Project	CMHA Meadows RAD Renovations	Addendum Number	2
Project Number	18076.04	Date	06/23/2026
To	All Bidders		
<i>This addendum contains changes to the requirements of the bidding Documents, Project Manual and Construction Drawings which have been issued to date. Such changes are to be incorporated into the Construction Documents and shall apply to the work in the same meaning and force as if they had been included in the original documents. Wherever this Addendum modifies a portion of a paragraph of the Project Manual or a portion of any Drawing, the remainder of the paragraph or Drawing shall remain in force.</i>			
Q&A	1. In regard to the new backflow preventer, is the water service currently routed correctly? The water lines are shown per record plan and correct to our knowledge. They are shown per the water service plan that was reviewed and approved through division of water.		
Specifications	REVISED UNIT PRICE on BID FORM. - DELETED UNIT PRICE #3 - ADDED UNIT PRICE #6 & 7. Section 01 21 13 Allowance - ADDED Section. Section 01 22 00 Unit Price - REMOVED Section 3.01 C. - ADDED Section 3.01 F and G. Section 06 16 00 Sheathing - ADDED Section Section 09 51 13 Acoustical Panel

05/12/2026
DRAWN BY: XXXX CHECKED BY: XXXX
18076.04
G003
BID SET

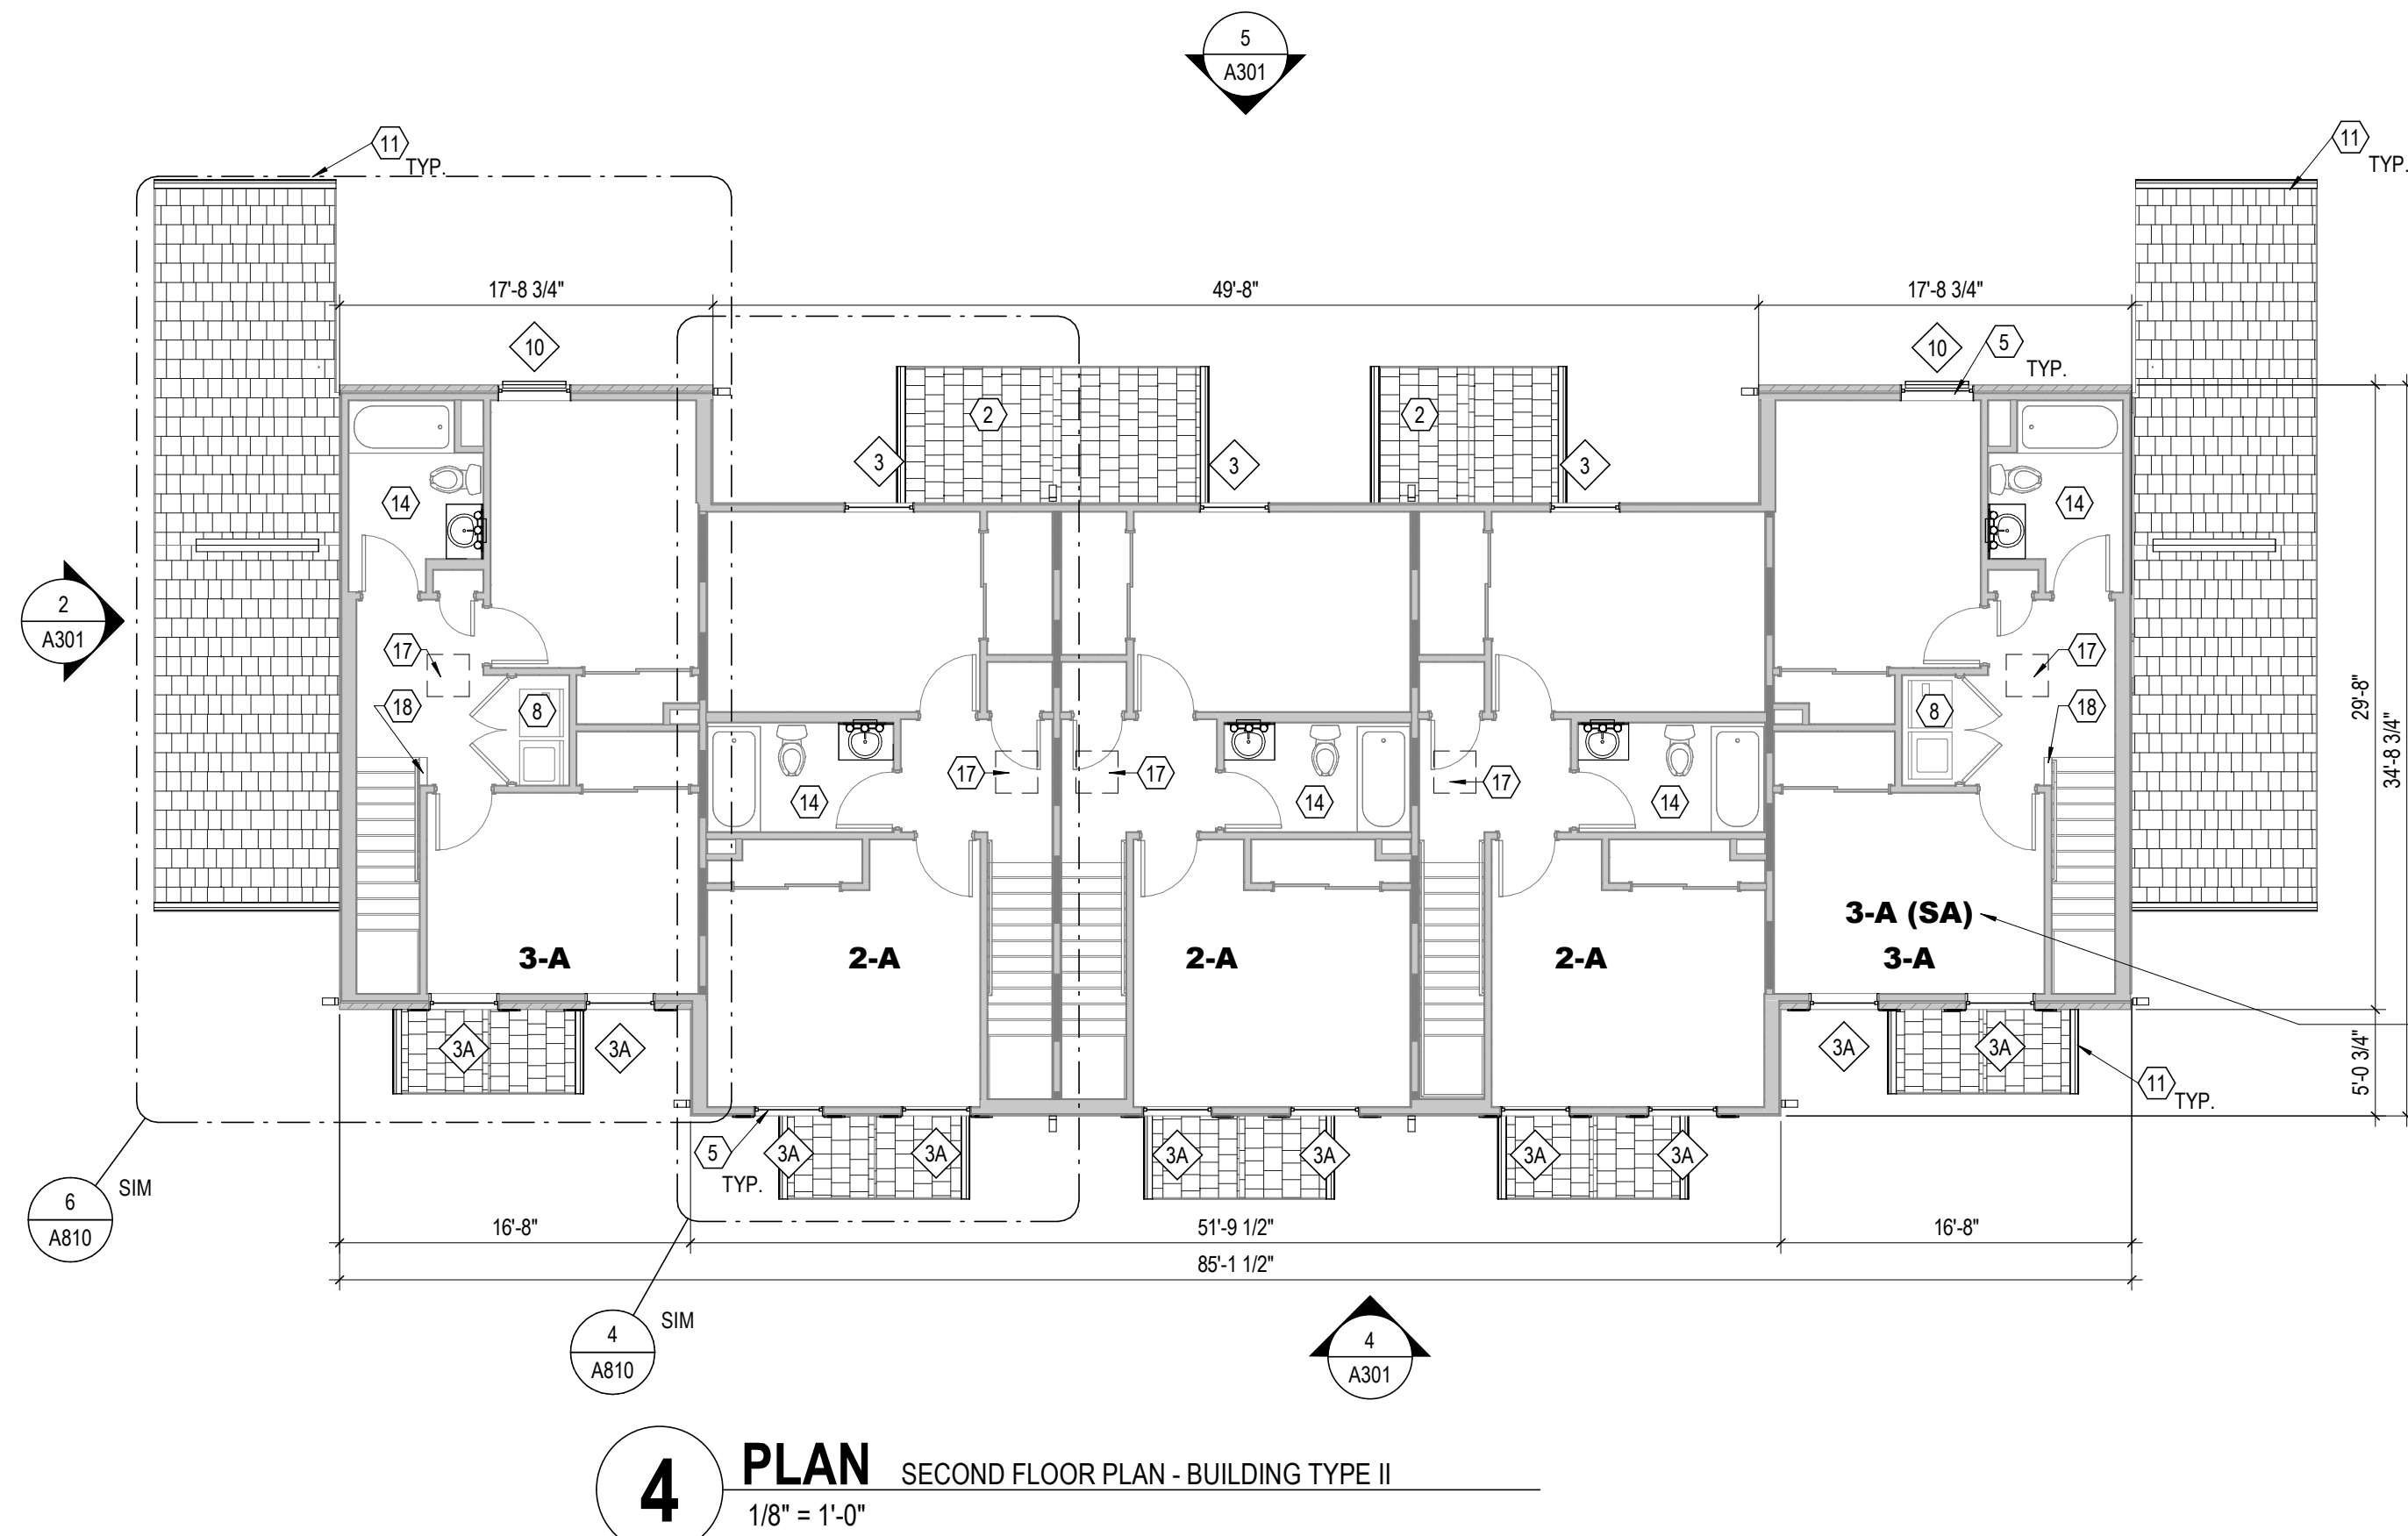
Civil	Sheet C102 – FINAL SITE COMPLIANCE PLAN REVISE Coded Note 10 to “REMOVE MULCH AND REPLACE. COORDINATING EVENTS WITH EQUIPMENT PROVIDER. PROVIDE NEW POURED PLAY SURFACE AND PROVIDE AND INSTALL NEW TRASH RECEPTACLE TO MATCH EXISTING BENCHES”		
Architectural	Sheet G003 - SITE INFORMATION - Under CODED NOTES – SITE PLAN, REMOVED “FENCING &” in coded note no.1. Sheet A101 – OVERALL FLOOR PLANS – TYPE I & II - REVISED Coded Note 14 - EXISTING MIRROR/MEDICINE CABINET, VANITY, TOWEL BARS & TOILET PAPER DISPENSER TO BE REMOVED & REPLACED WITH NEW IN TYPICAL UNIT. MIRROR/ MEDICINE CABINET IN ANSI TYPE A UNITS TO BE LOWERED, CLEAN & RECAULK. NEW CULTURED MARBLE VANITY COUNTERTOP WITH INTEGRAL BOWL & BACKSPLASH. EXISTING WATER CLOSET, TUB & SURROUND TO REMAIN, CLEAN & RECAULK. SEE PROJECT DETAILS & SPECS.

Sheet A810 – ENLARGED PLANS – UNIT TYPE 2A, 2B (ANSI-A) & 3A

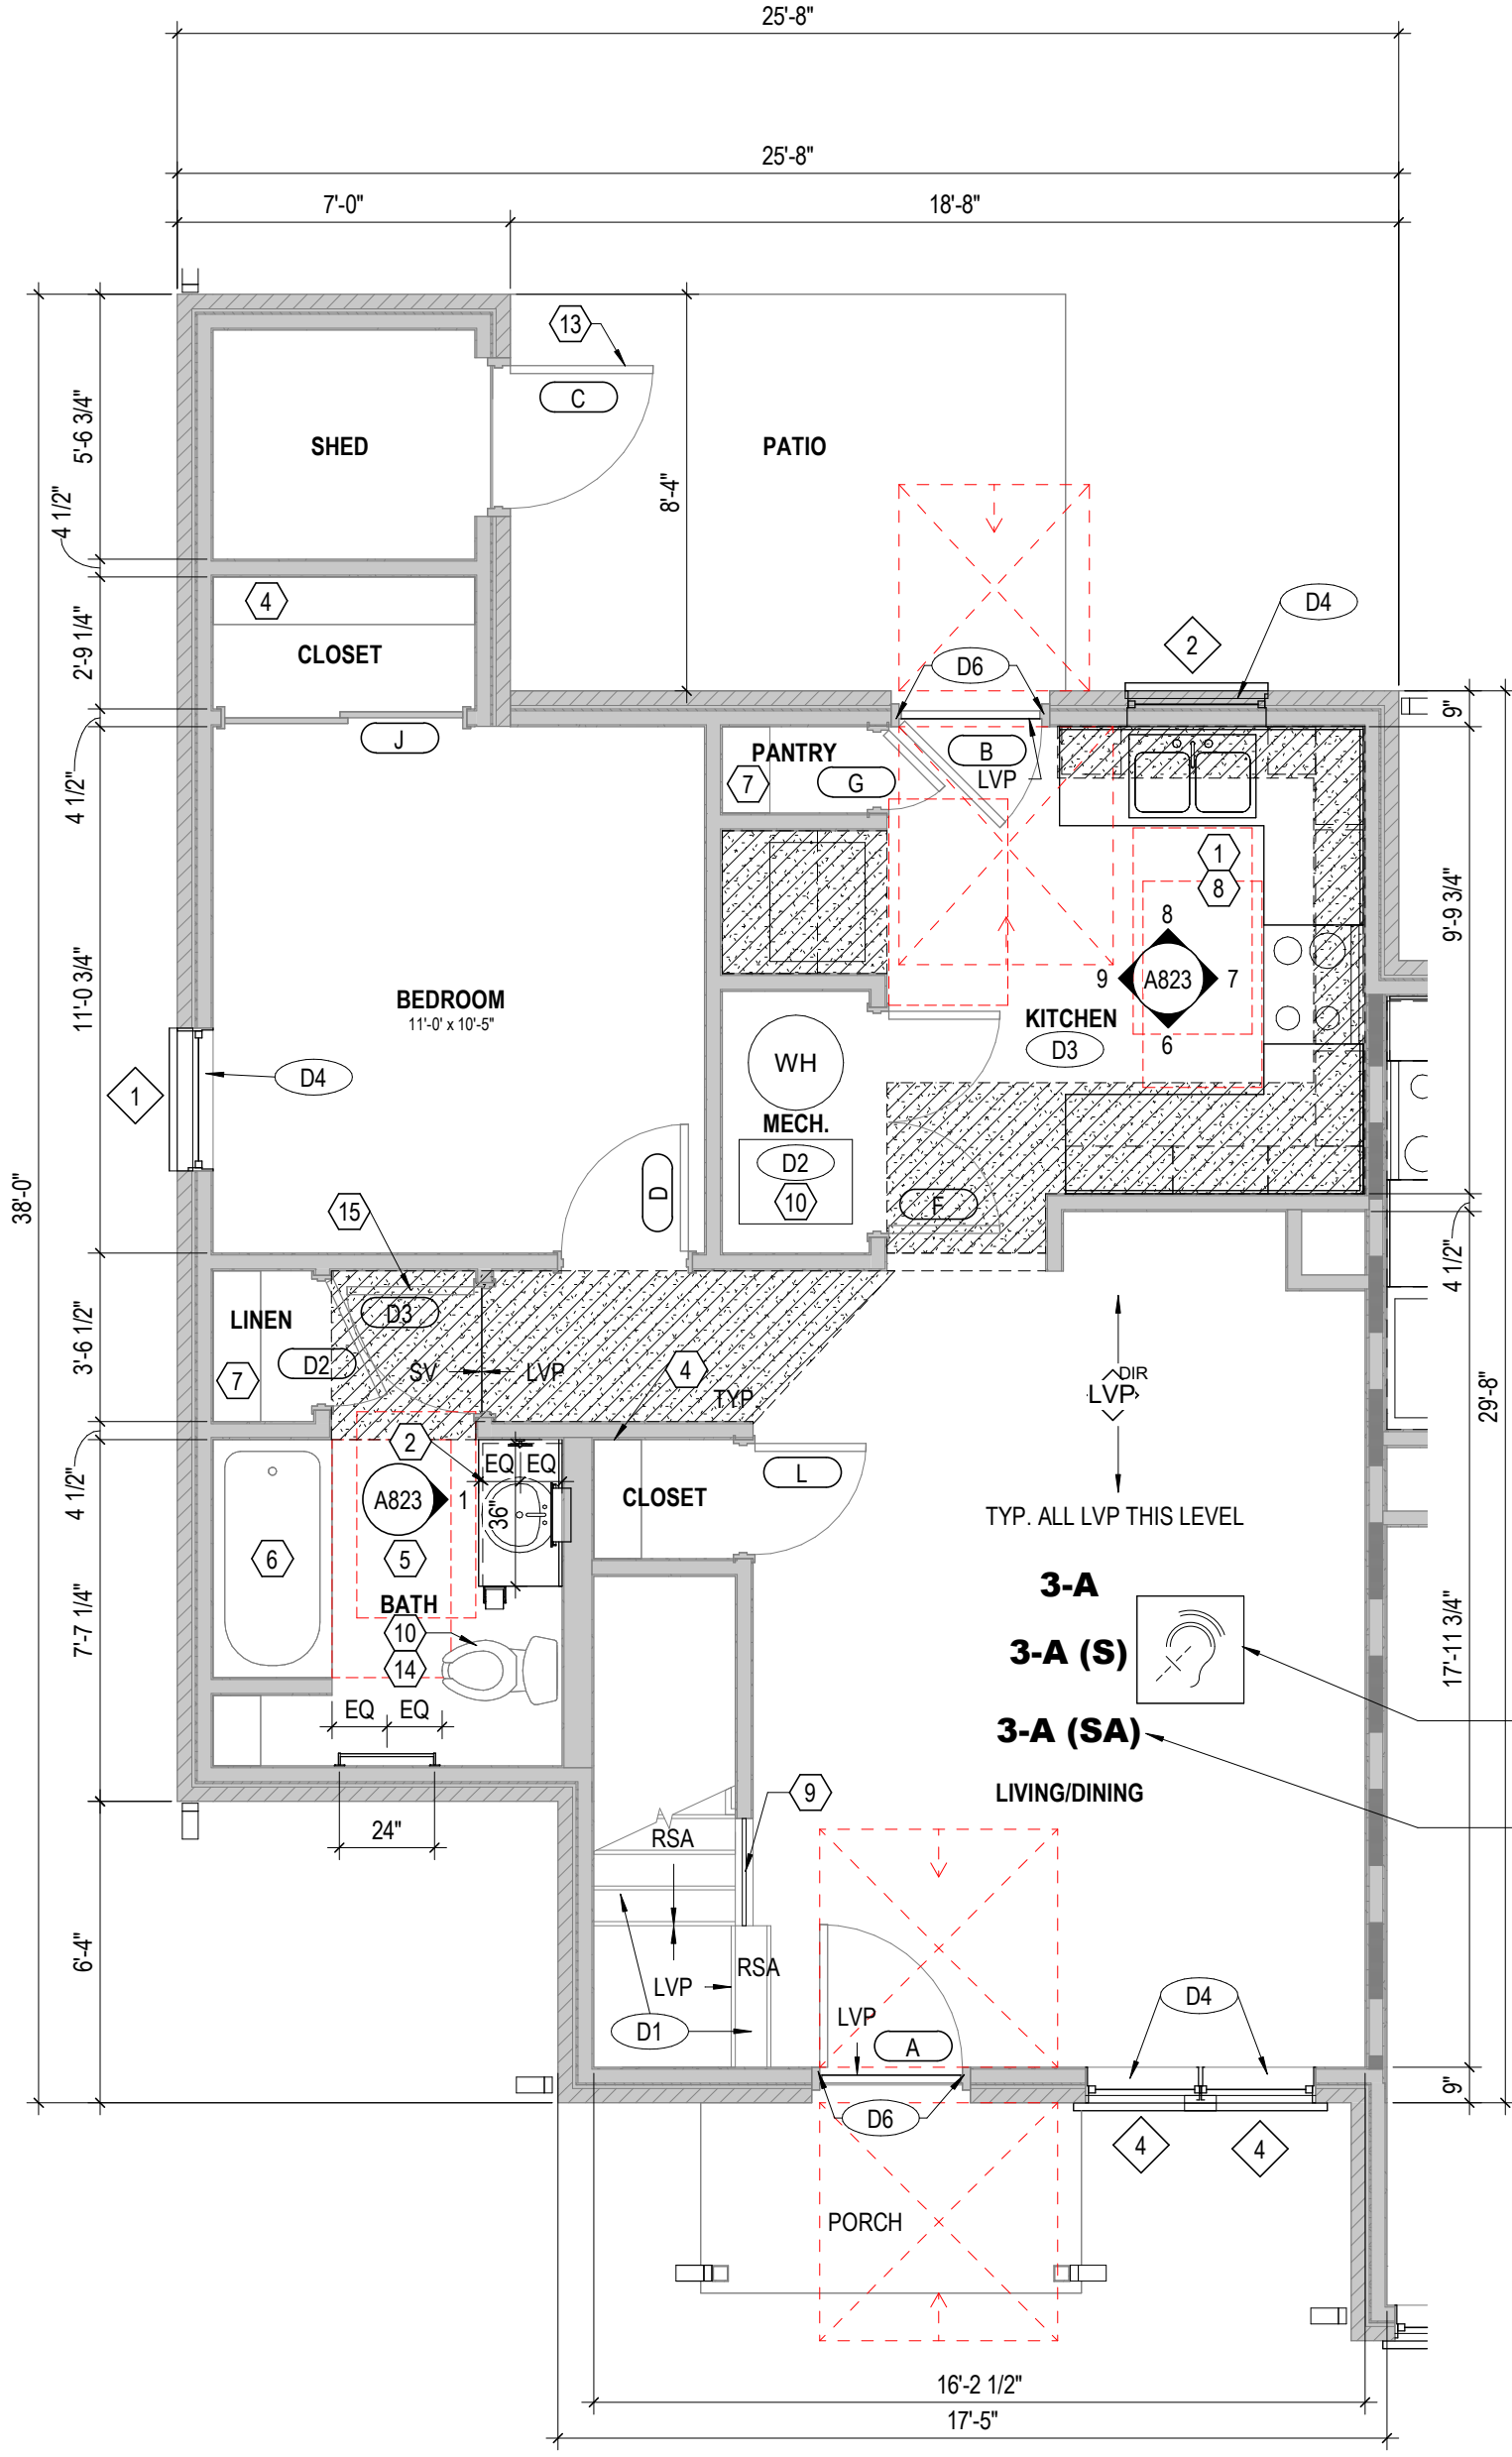
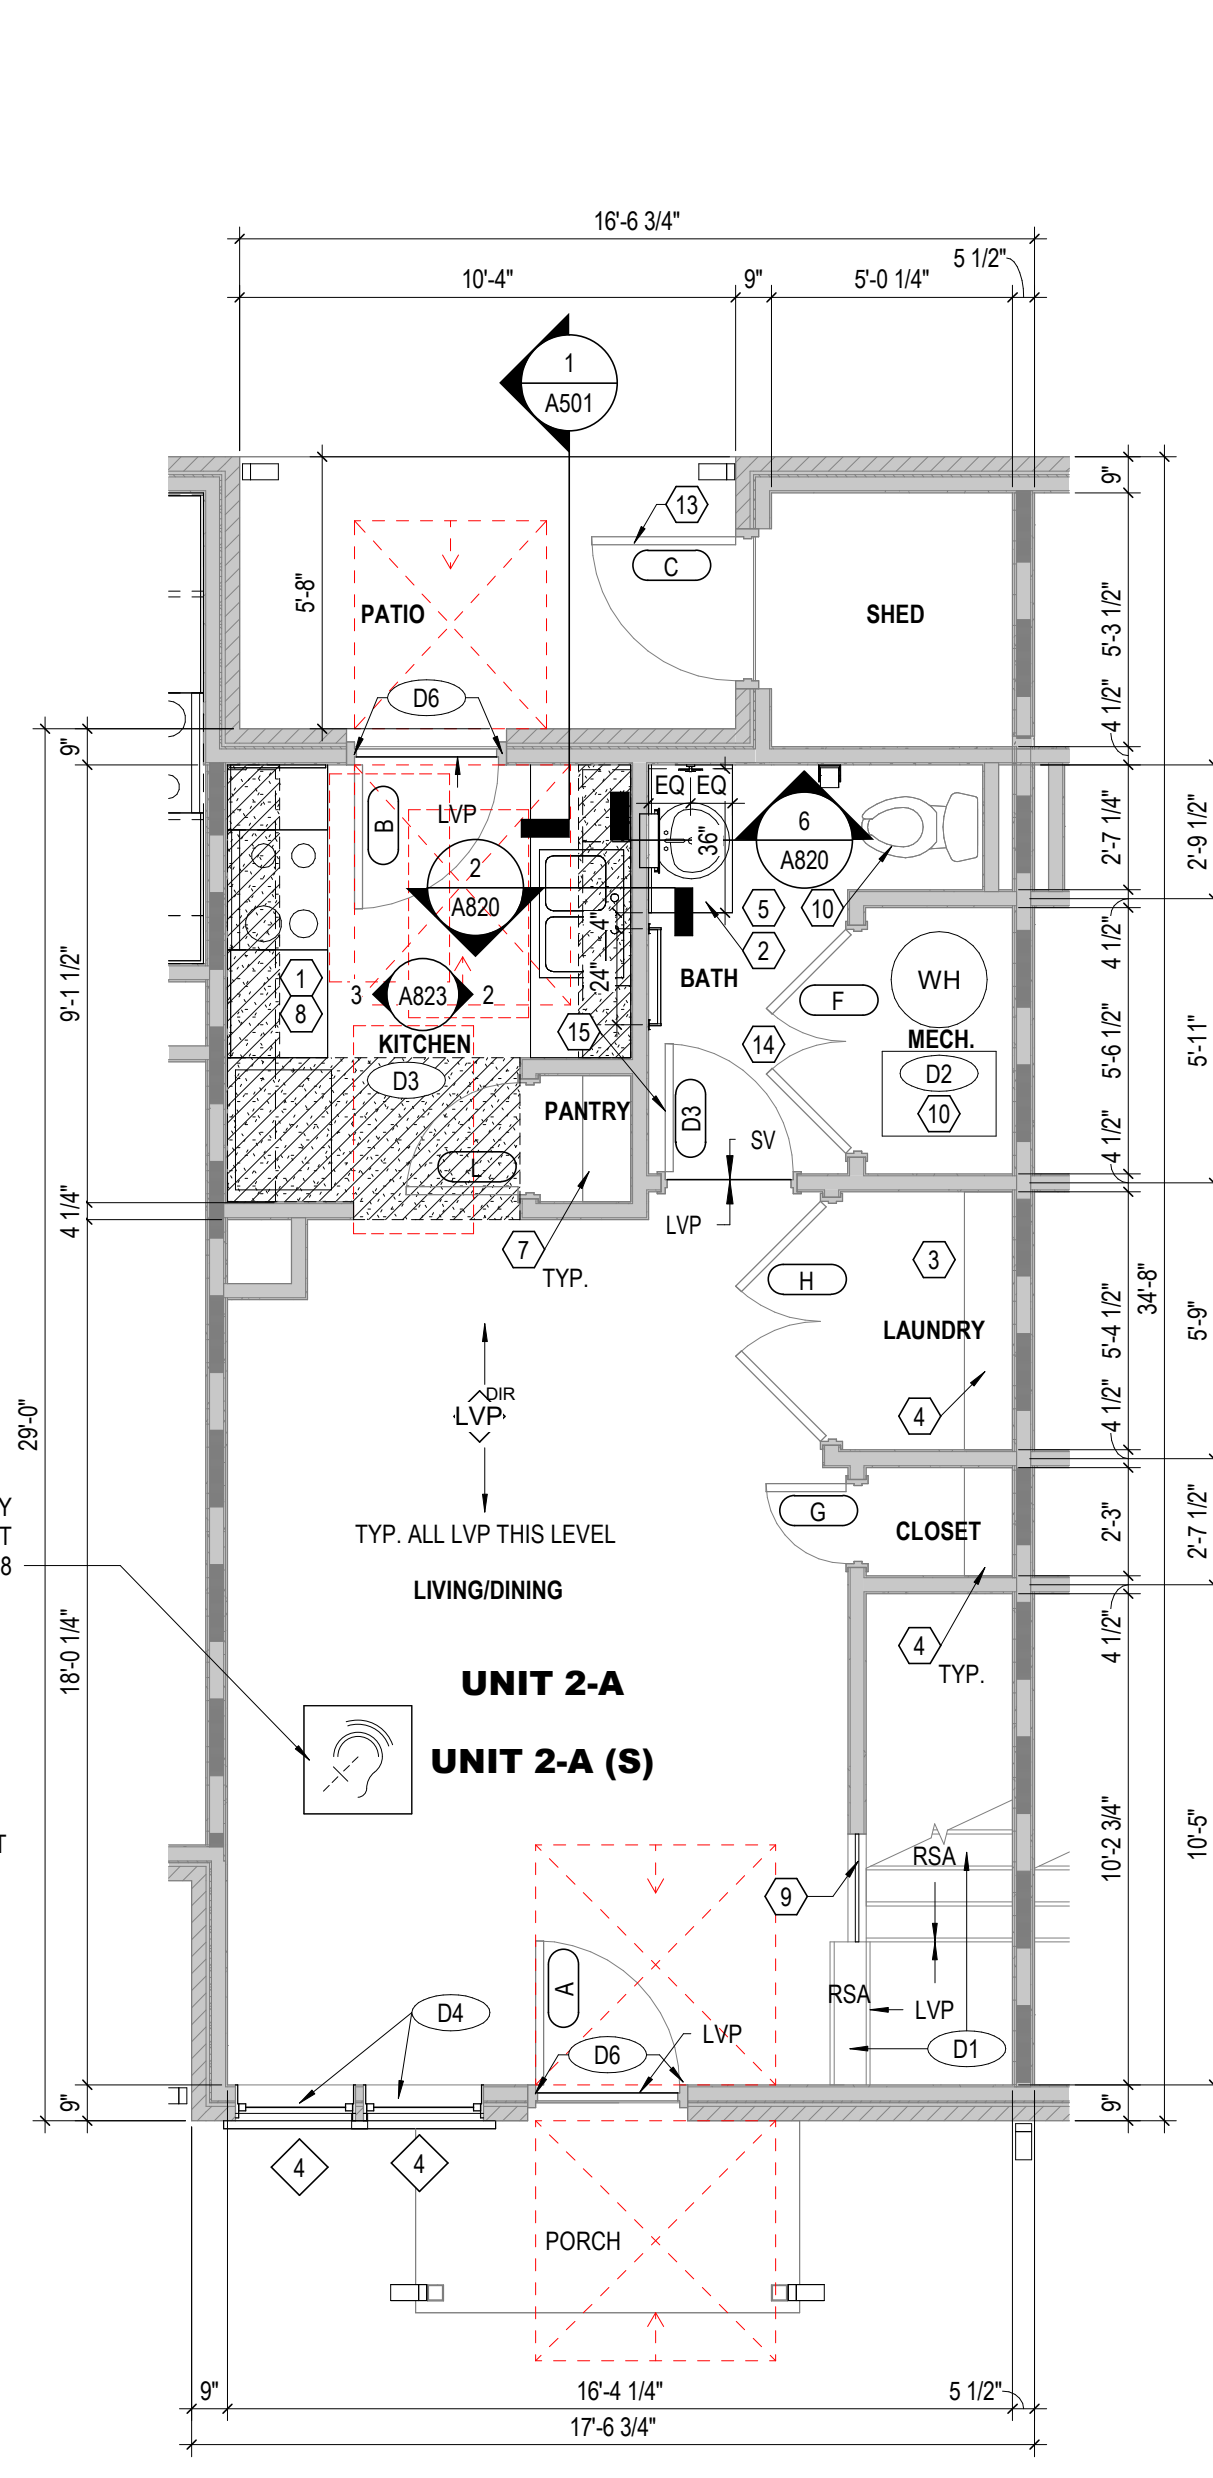
1. REVISED General Note I to “NOT USED”.
2. Under GENERAL NOTES – UNIT PLANS, ADDED TT. PROVIDE 1/4” THICK LUAN UNDERLAYMENT AT ALL AREAS IN ALL SECOND FLOOR UNITS.
3. REVISED GENERAL NOTES – UNIT PLANS P.
- a. EXISTING TUBS AND SURROUND TO REMAIN. **MIRRORED MEDICINE CABINETS TO BE REPLACED.** UNO. CLEAN ALL TUBS, SURROUND & RE-CAULK ALL JOINT, TYP.
4. REVISED Coded Note 5
- a. EXISTING MIRROR/MEDICINE CABINET TO BE **REMOVED & REPLACED** IN TYPICAL UNITS. **NEW MIRROR/MEDICINE CABINET IN ANSI TYPE A UNIT TO BE INSTALLED LOWER.** REFER TO TYPICAL PROJECT DETAILS FOR ADDITIONAL INFO.
5. Note applies to all Enlarged Plans (A810 through A811)
